Project CENTRAL / RIDGE Rd Intersection

Project Number 472 83057000 001 / Index Code 706805

SWS change:

Sketches, etc.

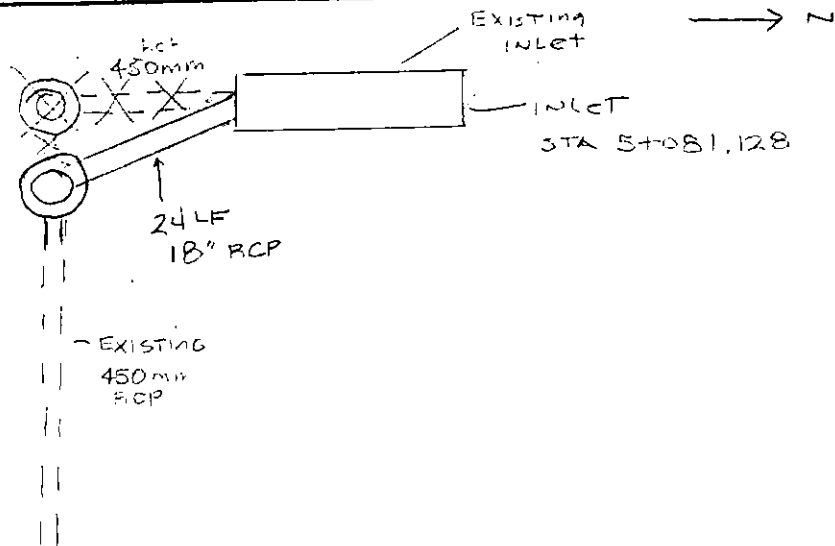
REMOVED SWS MANHOLE IN TOTAL DRIVEWAY STA

REMOVED SWS PIPE 18" RCP

USED EXISTING FLOW LINE GRADE @ INLET LAID 18" PIPE SOUTHEASTERLY

Removed 18" RCP South to MH
Removed MH @ STA
